RE: **Zoning Atlas Map Amendment
 Site Plan (Development & Design Review) Approval**

BOARD DATE: October 11, 2021

STAFF REPORT

**Subject: Rezoning, Site Plan, and Subdivision – Oleander Oaks
Technical Review Project # 21-43900001 & 21-09000001**

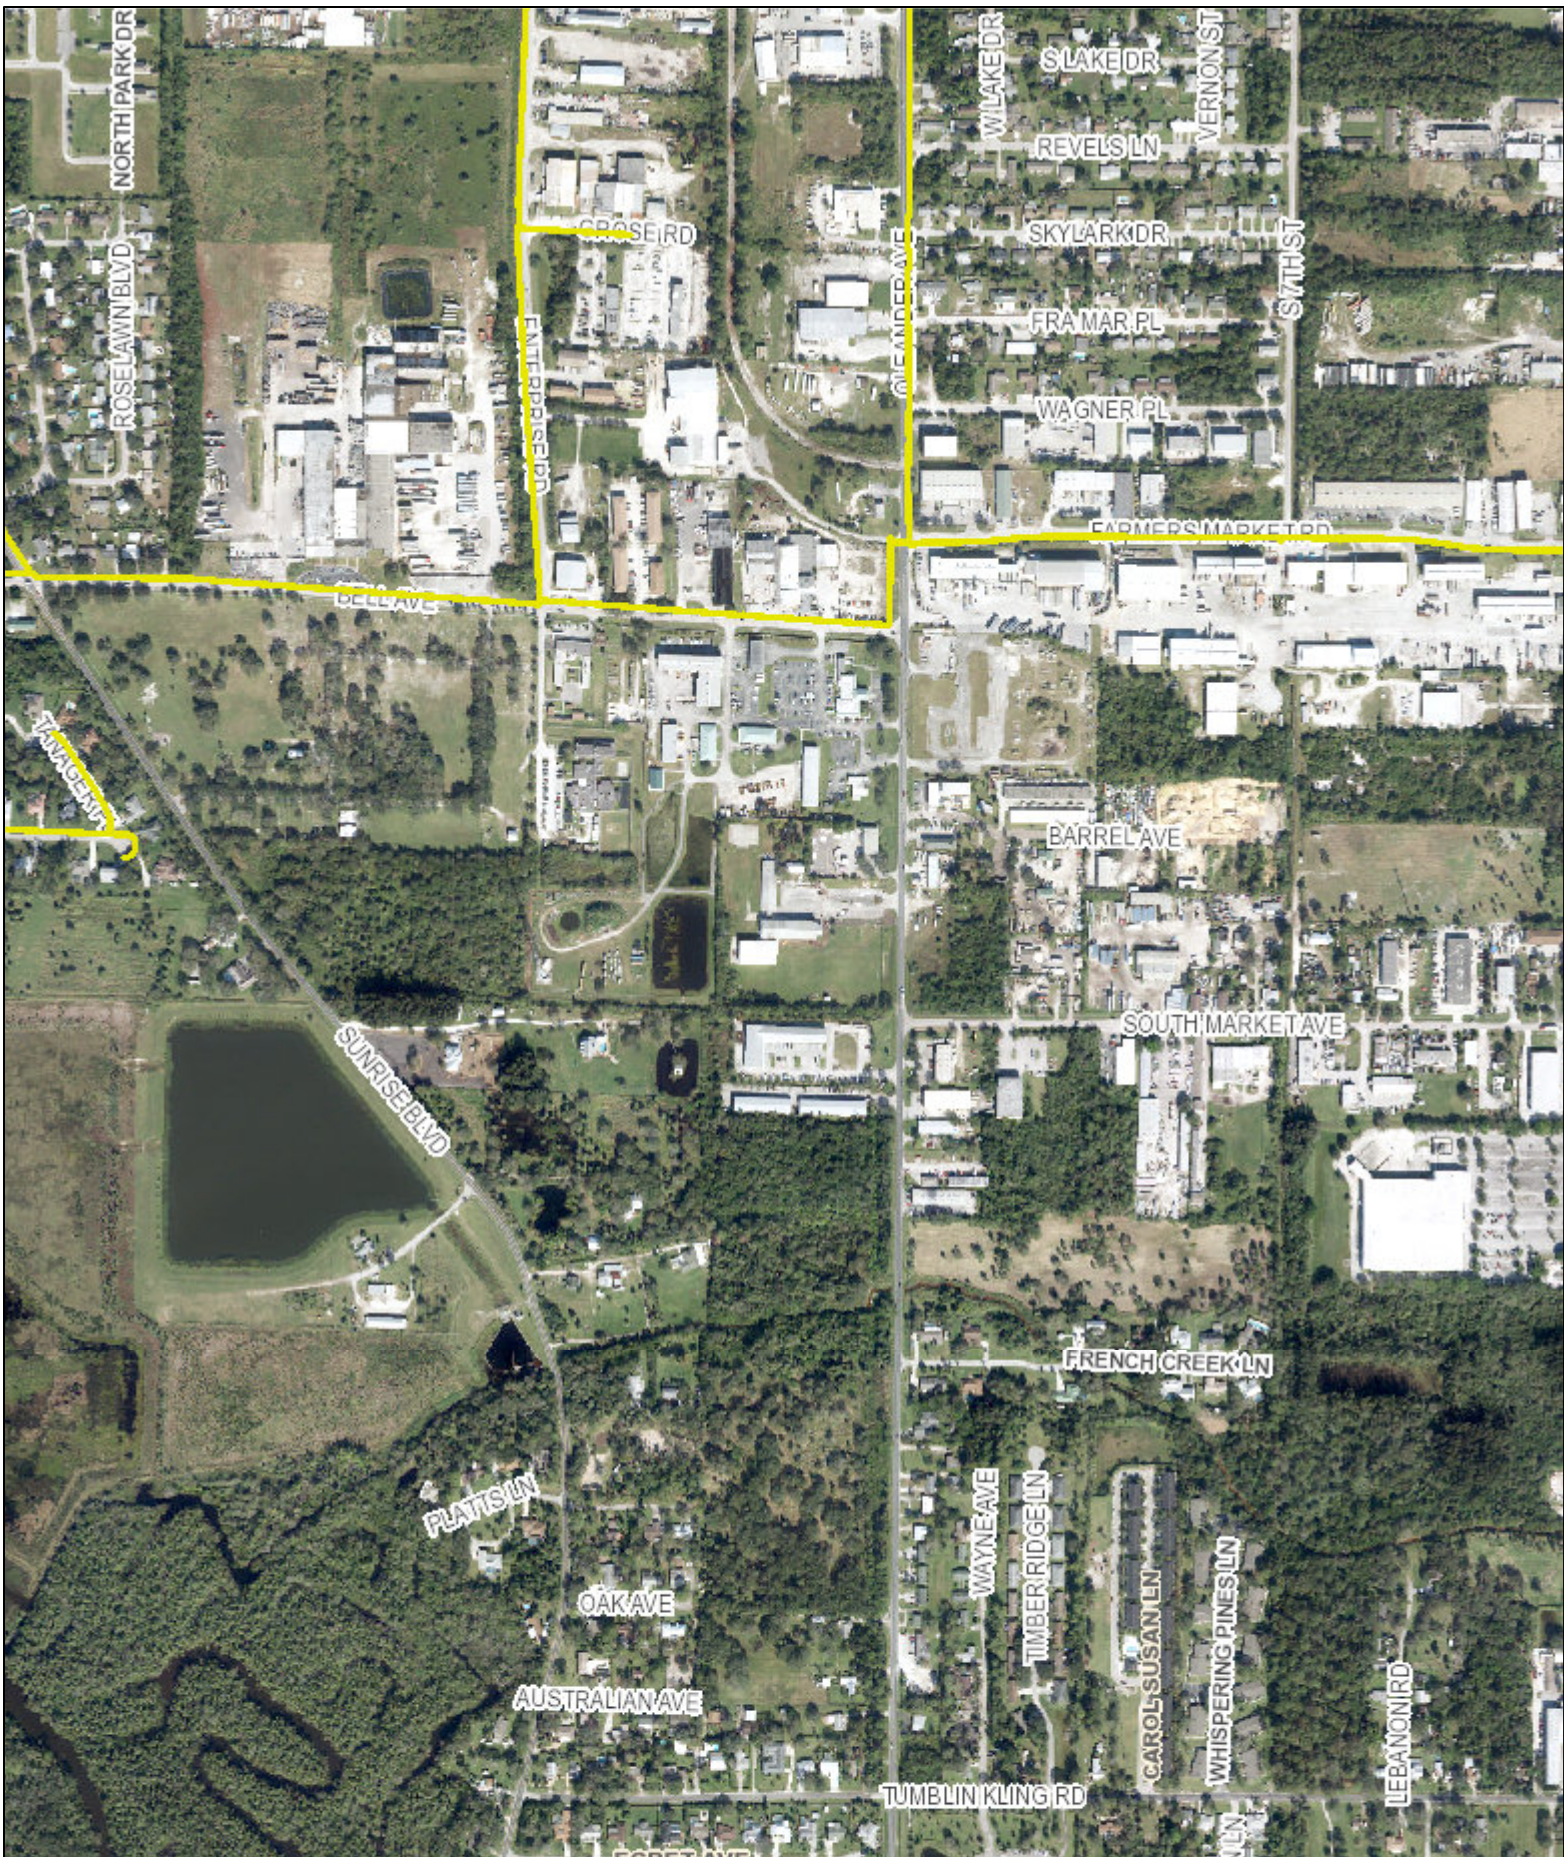
FPUA will require a utility easement for all propose FPUA facilities. Please find attached a copy of the FPUA GIS map (Gas).
